ADDENDUM

Project: LPS Project D
Bid Package #7636-D

Project No.: 14-022

Addendum No.: 2

Detail 10 – AV Gearbox

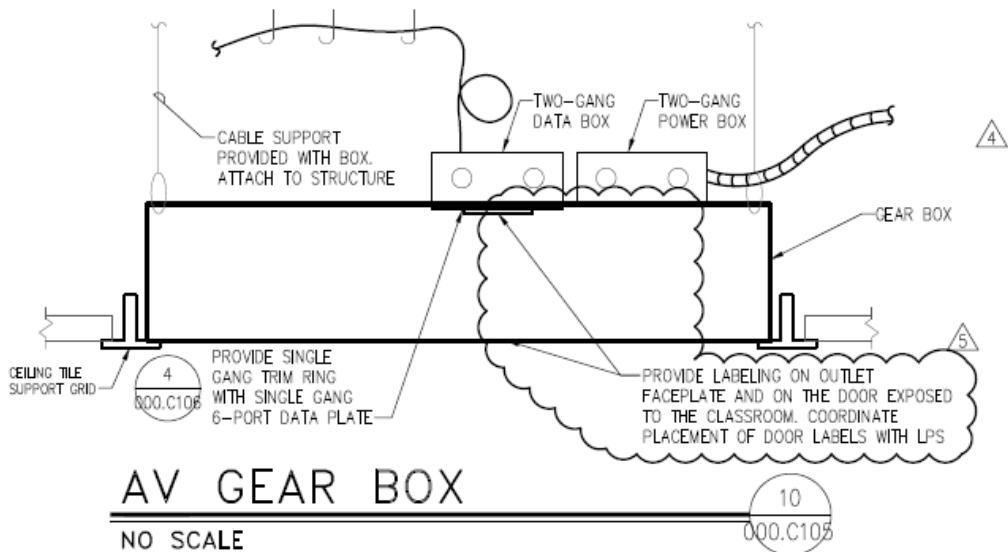
1. See below clouded area for modifications to detail, indicating required labeling.
